### APPEAL SUMMARY

<b>Appeal ID:</b> 20403	<b>Project Address:</b> 5901 SW Macadam Ave
<b>Hearing Date:</b> 5/15/19	<b>Appellant Name:</b> Daniel Young
<b>Case No.:</b> B-013	<b>Appellant Phone:</b> 503-228-9747
<b>Appeal Type:</b> Building	<b>Plans Examiner/Inspector:</b>
<b>Project Type:</b> commercial	<b>Stories:</b> 2 <b>Occupancy:</b> B <b>Construction Type:</b> III-B
<b>Building/Business Name:</b> B P John Building	<b>Fire Sprinklers:</b> No
<b>Appeal Involves:</b> Alteration of an existing structure	<b>LUR or Permit Application No.:</b>
<b>Plan Submitted Option:</b> pdf [File 1]	<b>Proposed use:</b> B (Office)

#### Appeal item 1

**2ND FLOOR PLAN - EXISTING**

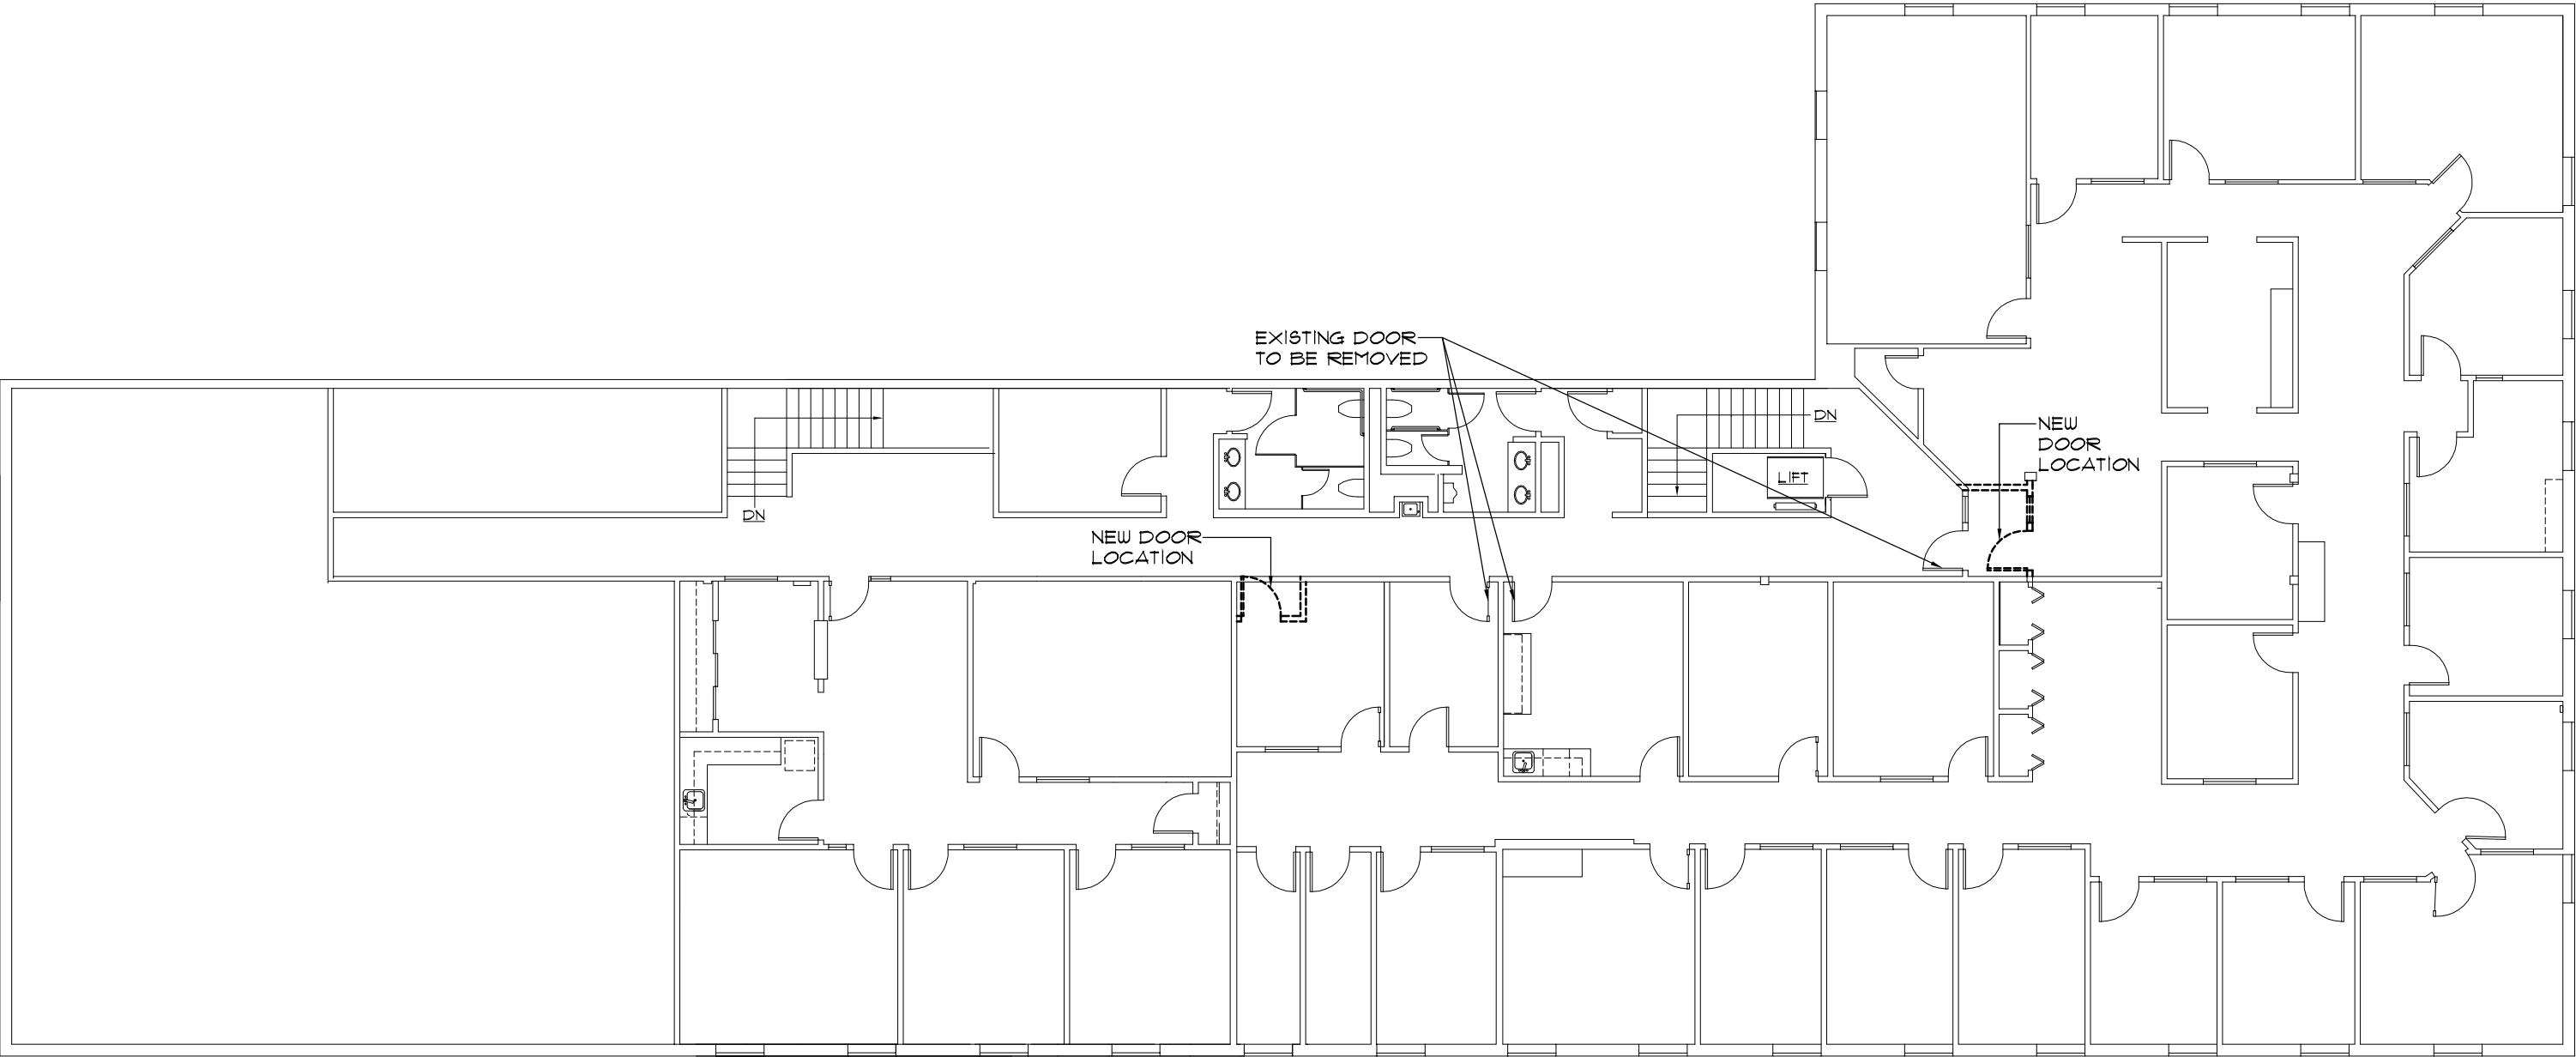
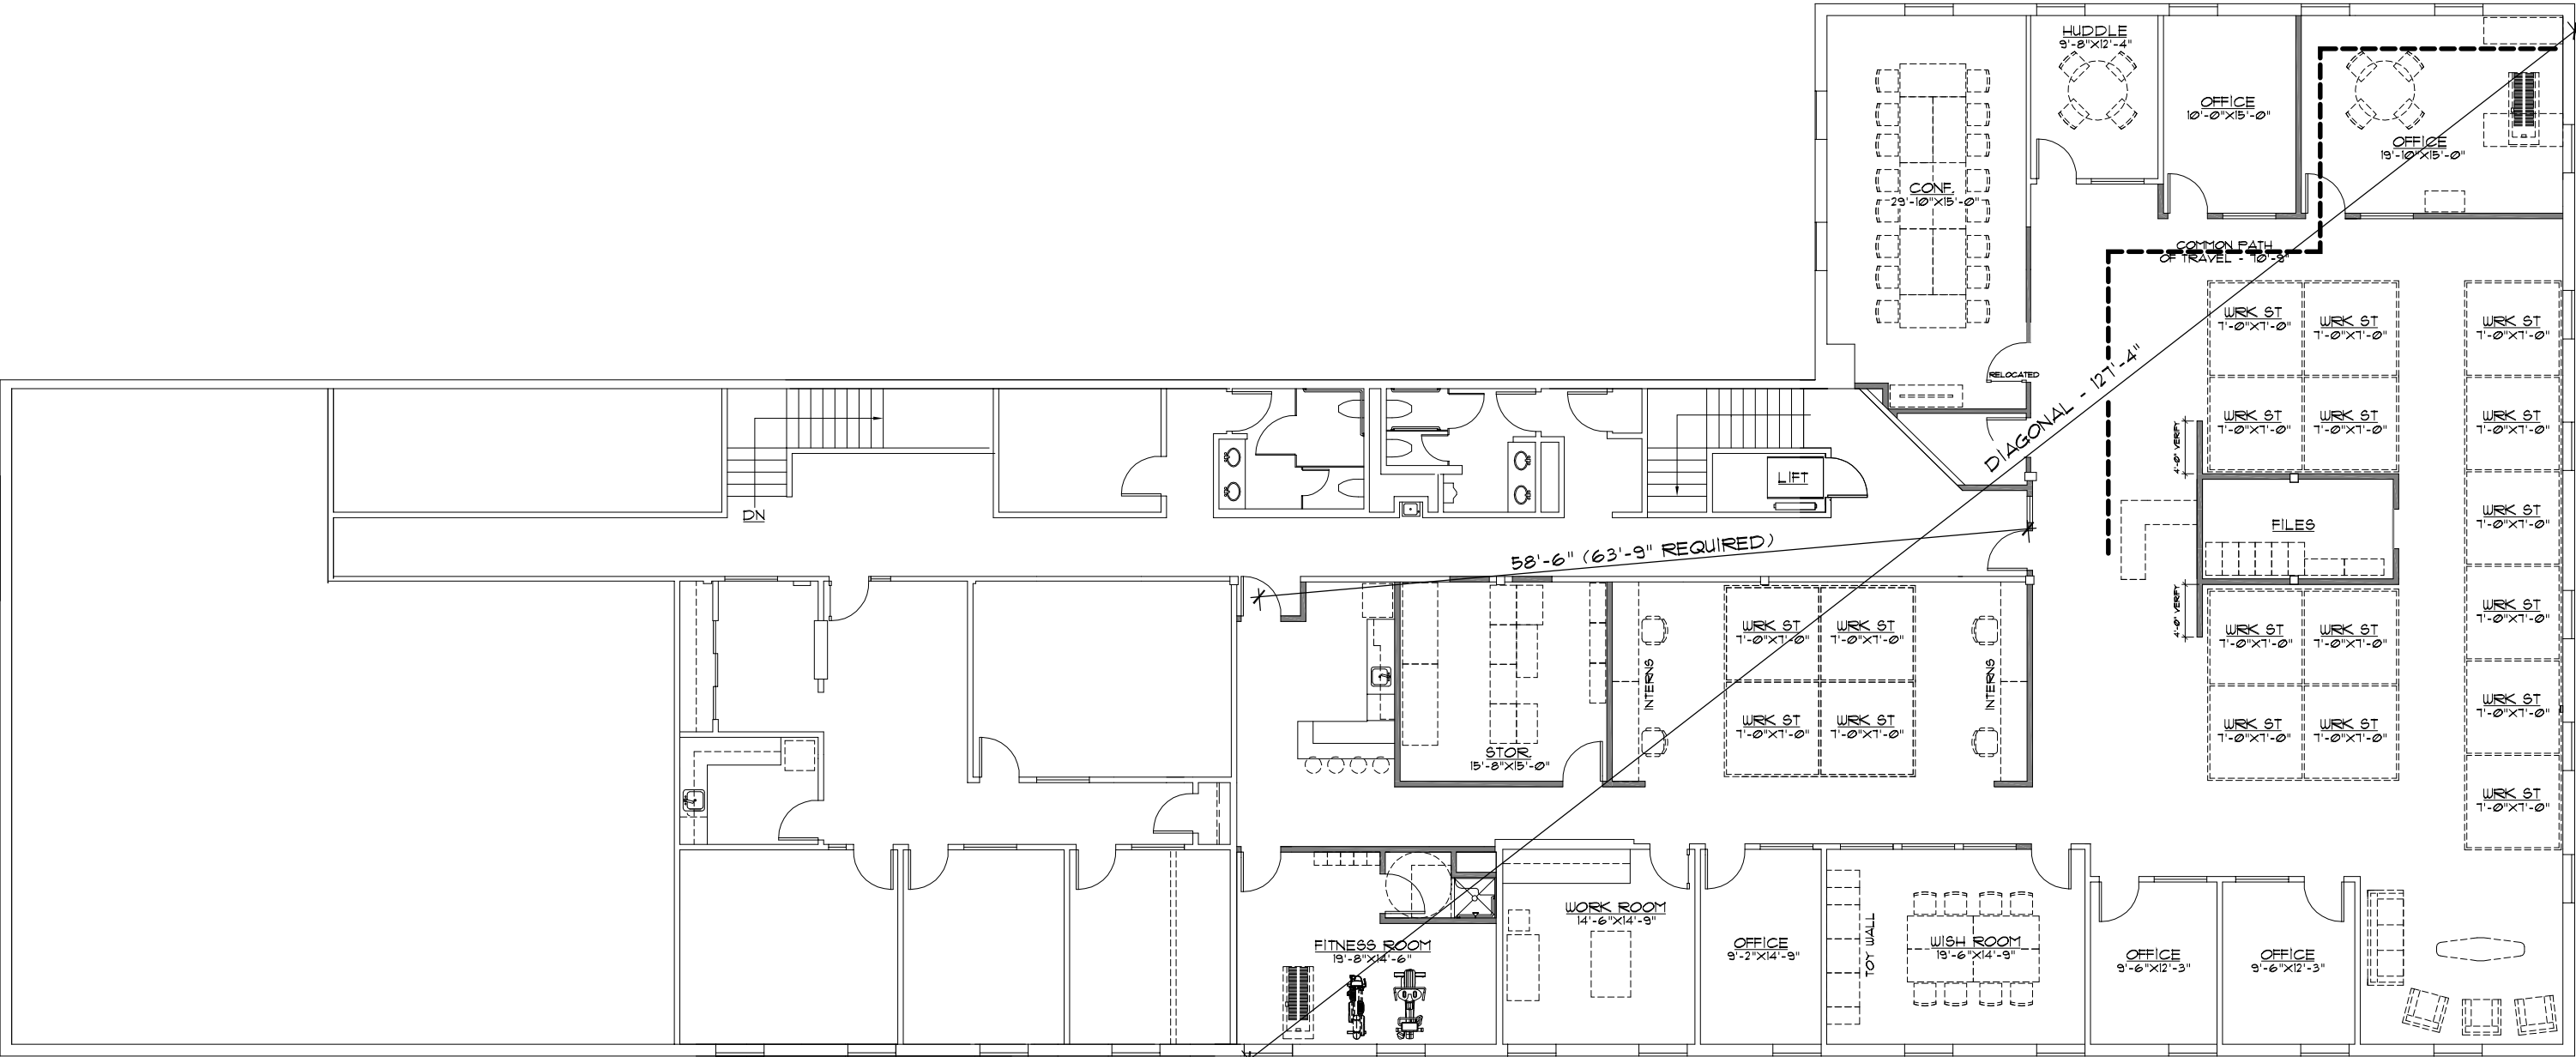
**Proposed Design** Per the above stated code section, the Exit Access Doorways are to be separated by 63'-8". The proposed design is for a separation of 58'-6".

**Reason for alternative** This 19,800+/- sq. ft. 2-story building was built in 1975. Due to the layout of this building and this tenant space (5,780 sq.ft), it is not possible to achieve the required Exit Access Doorway separation. In the proposed plan, both exits are moved to provide maximum separated. Equivalent life-safety is provided by creating a more open plan which allows for improved sight lines throughout the space (Compare Existing Plan to Proposed Plan). Exit signs and egress lights (both w/ battery back-up) along the Exit Access within the tenant suite will also be added.

**Reduction in minimum required exit access separation distance: Hold for additional information.**
